Melville Thomas Architects, Inc.

M E M O

VA EXPANSION GARAGE

VA Expansion Parking Garage Bidder Questions From Dawn Carroll-Amin:

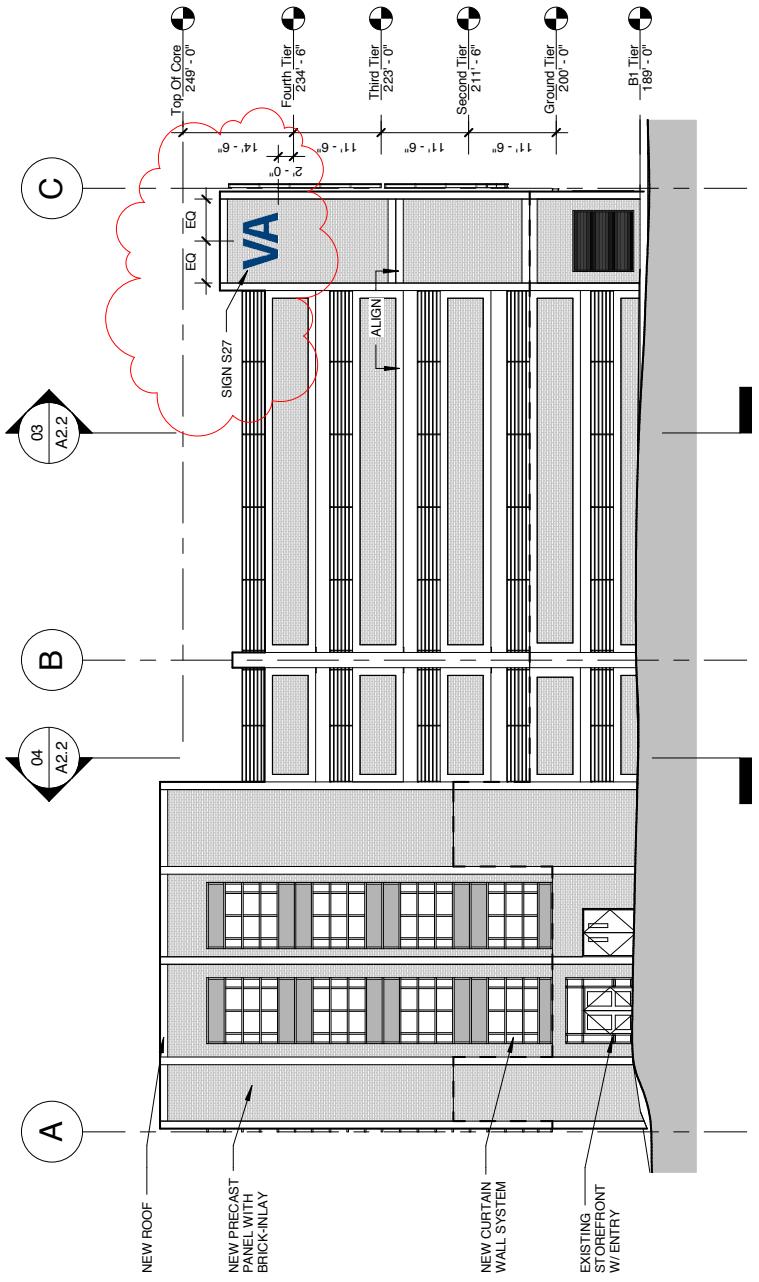
18. Detail 4 shown on drawing LP7.1 shows spacing for the main concrete incased bollards to be min. of 50' and a max of 200'. Is the contractor to decide on spacing from 50' to 200'.

The contractor may determine the length in the field based on a minimum of 50 LF and a maximum of 200 LF without bends.

SK3
VA MEDICAL CENTER
ADDENDUM 1
04/28/16

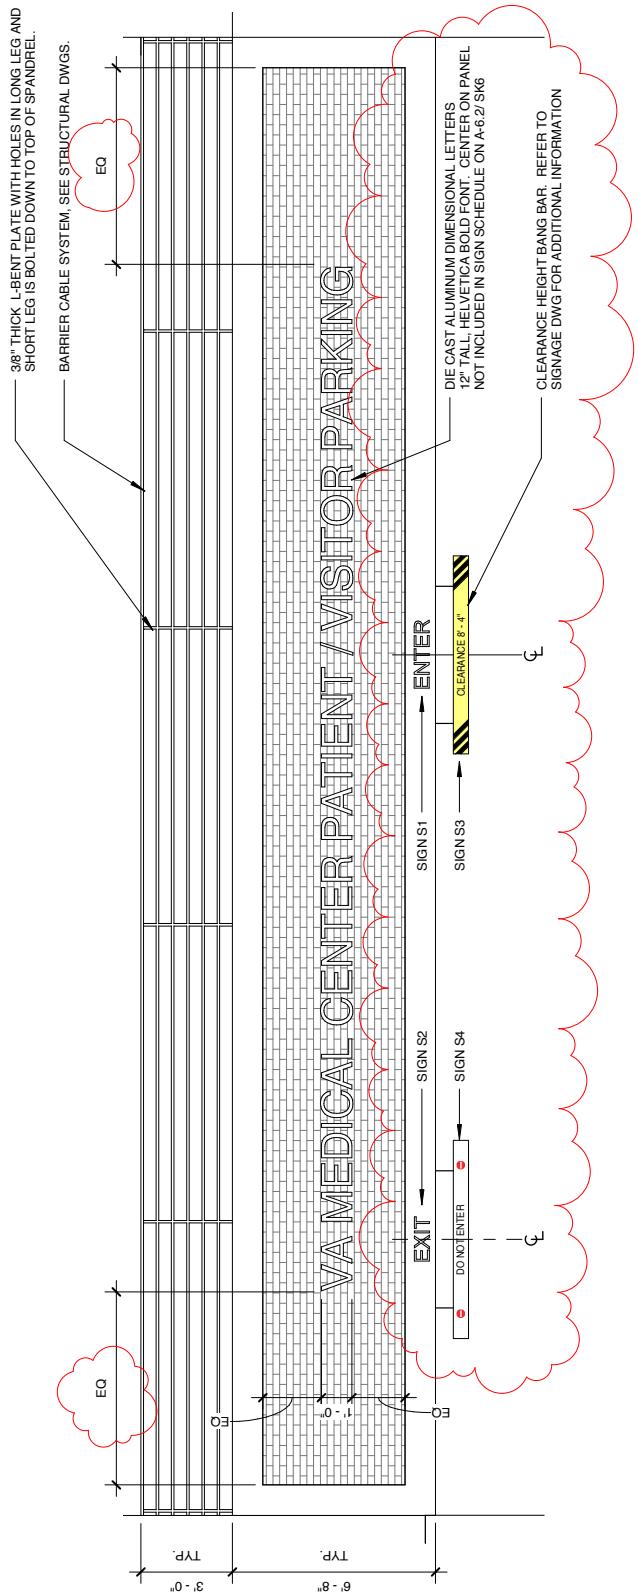
4. For the new exterior dimensional letters at the entrances/exits as shown on elevation drawing 01/A2.1 and 04/A2.1, the text reads, "VA MEDICAL CENTER PATIENT/VISITOR PARKING" (for both the East and South elevations). However, on the sign schedule on Sheet A6.2, the text reads, "ENTER" and "EXIT" for sign Type S1 and S2 respectively. Can you confirm which message is correct? (Drawing No. 01/A2.1 & 04/A2.1 & A6.2).

5. On the elevation drawing 01/A2.1 and 04/A2.1, it appears to show overhead wall mount panels, mounted centered above the in/out lanes (one for "In" with arrows and one for "Out" with do not enter symbols). However, there are no sign marks on the sign location plans (Sheet 01/A1.3 and 01/A1.4) indicating

these signs are required at these locations. Can you confirm if these overhead panels are required at the entrance/exit locations (Drawing No. 01/A2.1 & 04/A2.1).

"VA MEDICAL CENTER PATIENT/VISITOR PARKING" is not part of the parking directional sign package but is required in two locations as indicated on the elevation drawings. The materials, font, and dimensions are shown on the elevation drawings and detail. The "ENTER" and "EXIT" are scheduled signs (S1 and S2). The size of the lettering has been revised to 6" high. See the revised sign schedule SK6e attached and drawing SK 3 attached.

The elevation has been revised to say "ENTER" and "EXIT" to coordinate with the sign schedule. See SK 3 and SK 6 attached.

SK5
 VA MEDICAL CENTER ADDENDUM 1
 04/28/16

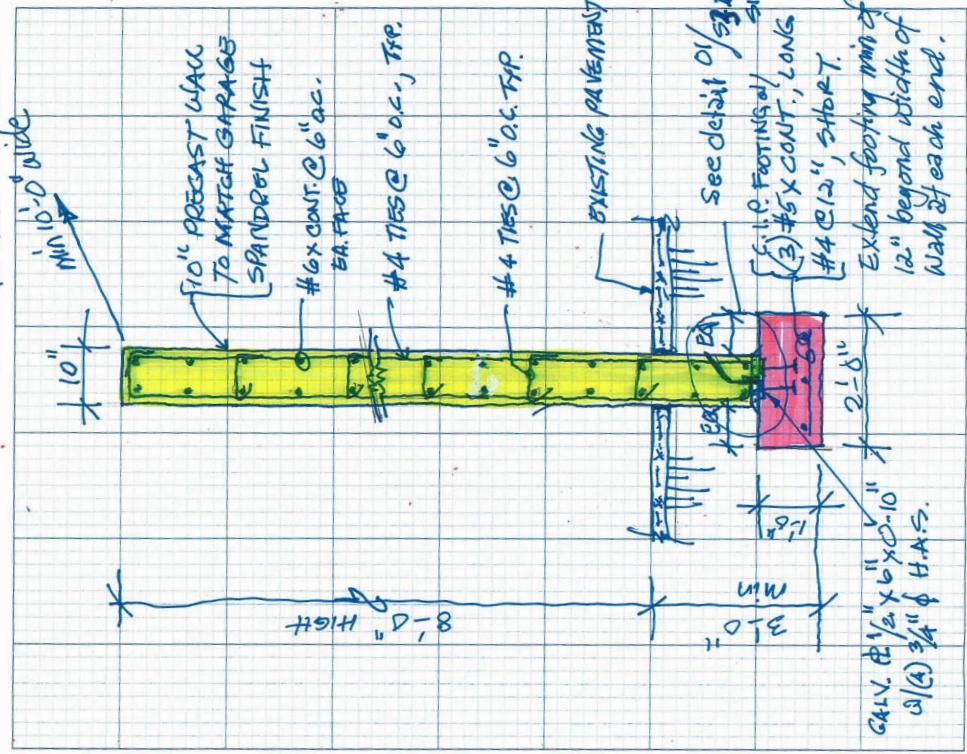
17. Blast Proof wall shown on drawing CS3.0 refers you to structural drawings for the details, which has no details. Please provide wall and foundation details.

See structural detail attached.
